Florida Gateway College  
 Building 17 – Anatomy/Physiology Renovations  
 Lake City, Florida  
 FGC Bid Number: ITB No. 20-3-01

April 20, 2020

Four

Permit Fee Structures and  
 Reissued Sheets P1, P2.1,  
 P3.1, P4 and E4

DATE 3/30/20  
DRAWN CAS  
APPROVED REC  
P1  
OF SHEETS

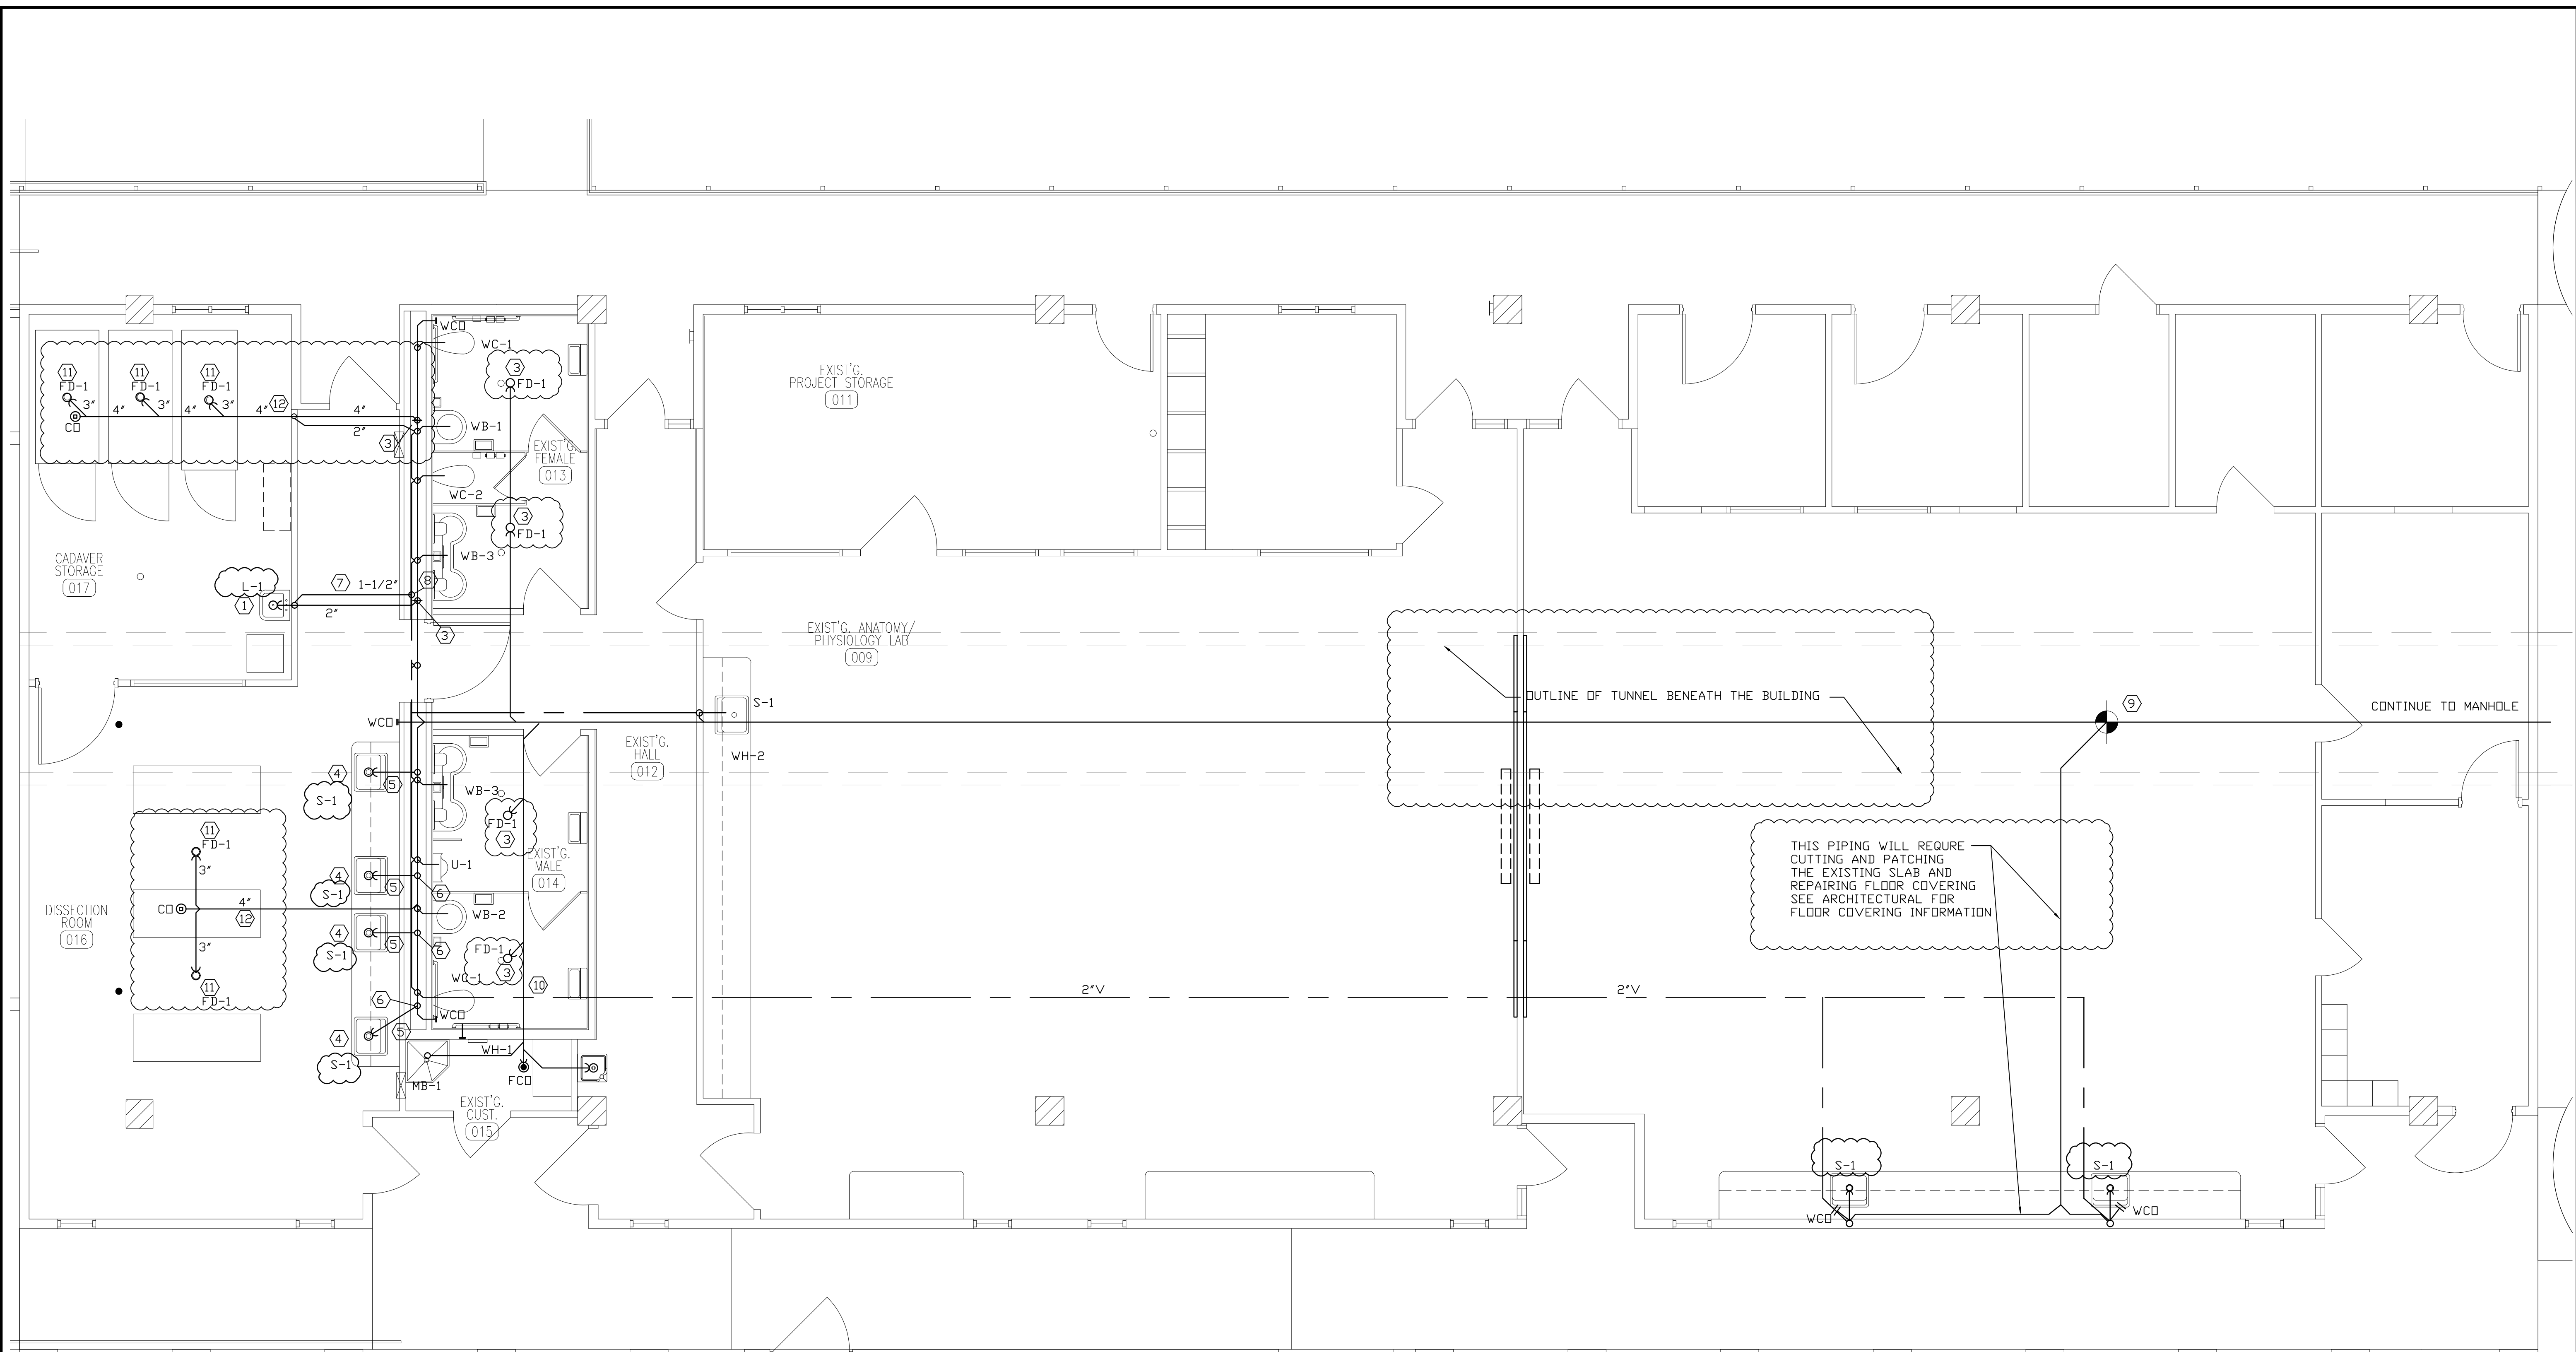
3. **DRAWINGS, SHEET P1 – PLUMBING SPECIFICATIONS, NOTES AND LEGEND:** Refer to the attached reissued Sheet. Revisions are indicated by cloud.
4. **DRAWINGS, SHEET P2.1 – NEW SANITARY PLAN:** Refer to the attached reissued Sheet. Revisions are indicated by cloud.

P3.1  
OF  
SHEETS

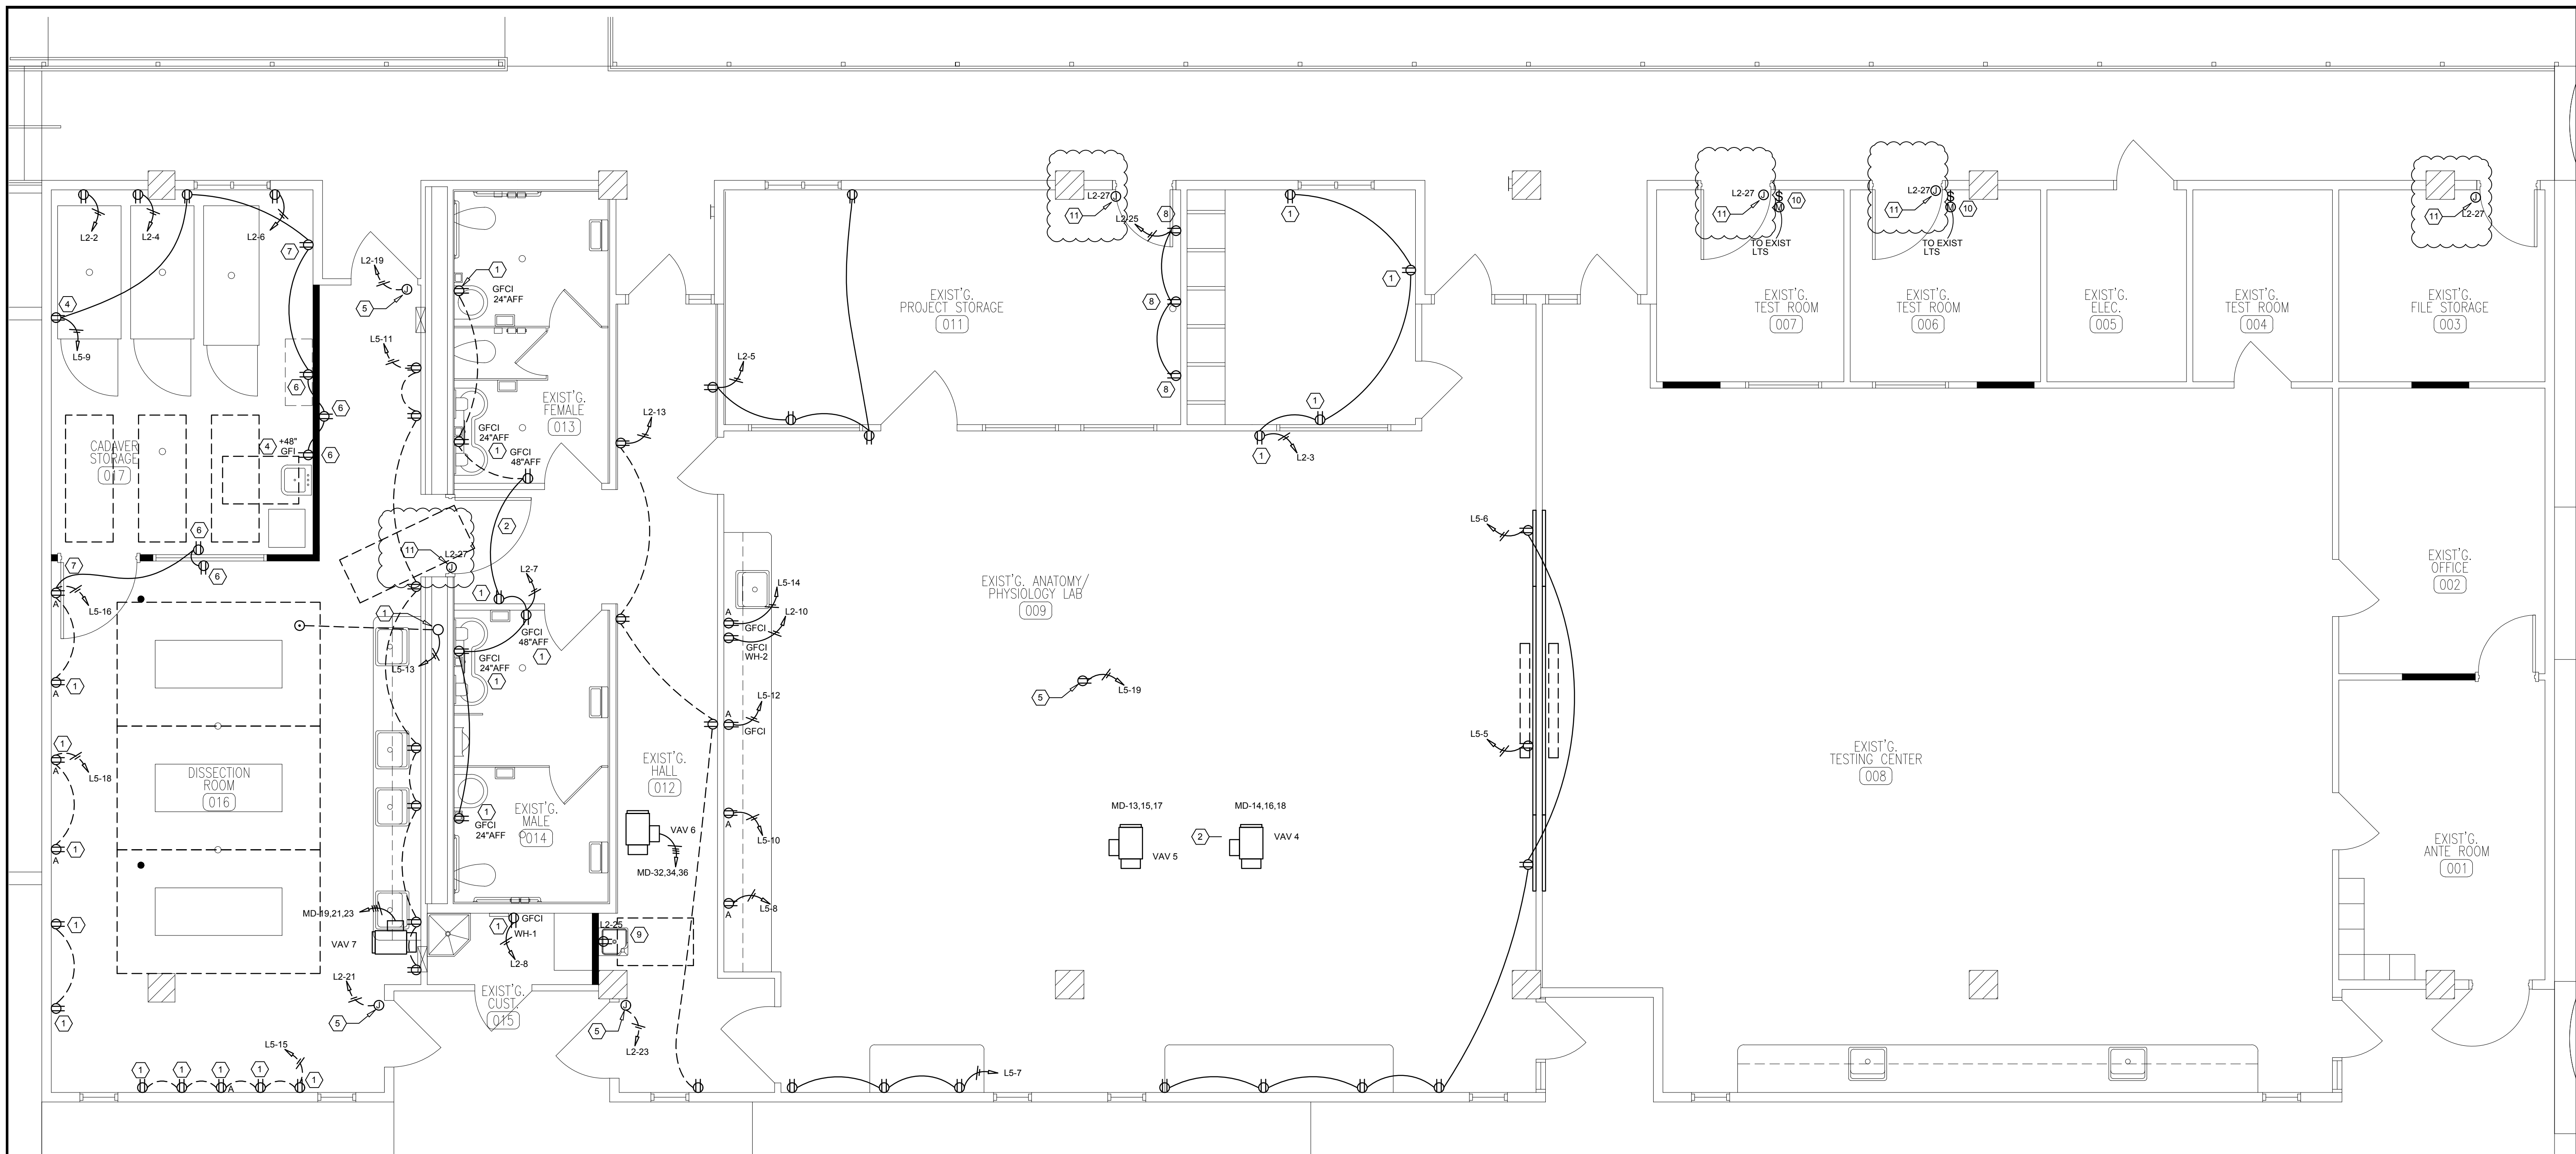
5. **DRAWINGS, SHEET P3.1 – NEW WATER SUPPLY PLAN:** Refer to the attached reissued Sheet. Revisions are indicated by cloud.
6. **DRAWINGS, SHEET P4 – PLUMBING RISERS:** Refer to the attached reissued Sheet. Revisions are indicated by cloud.

- KEYED WATER SUPPLY NOTES
- ① CONNECT NEW 1/2" WATER SUPPLY.
  - ② NEW 1/2"C TO NEW FIXTURE S1.
  - ③ NEW 1/2"C TO NEW HAND LAV L1.
  - ④ NEW RECIRC PUMP RP-1, SEE DETAIL X/XX.
  - ⑤ EXISTING FIXTURE.
  - ⑥ NEW WALL HUNG LAVATORY L1.
  - ⑦ RECIRC LINE CONNECT TO PUMP
  - ⑧ PROVIDE AN MX-1 VALVE UNDER THE LAV SEE DETAIL U
  - ⑨ NEW EVH-1 ON SHELF OVER JANITOR SINK SEE DETAIL 4 ON P4
